4 BODY

KEYLESS ENTRY SYSTEM

TRANSMITTER

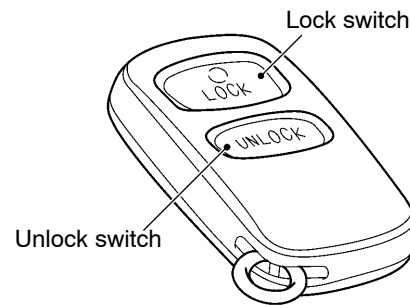
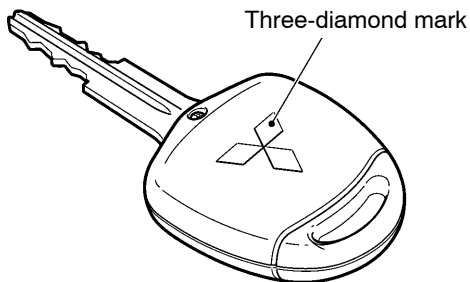
The shape of transmitter has been changed from the key ring type to the all-in-one type. Items other than below are the same as before.

- The shining silver Three-diamond mark is featured on the rear surface of key grip in order to enhance the texture of the key.
- The indicator lamp that illuminates at the time of signal transmission is added to the key grip so that signal transmission status and low battery can be checked visually.
- Since the transmission circuit (board) and the battery are contained in a case that is fit into the key grip, waterproofing capability can be improved.
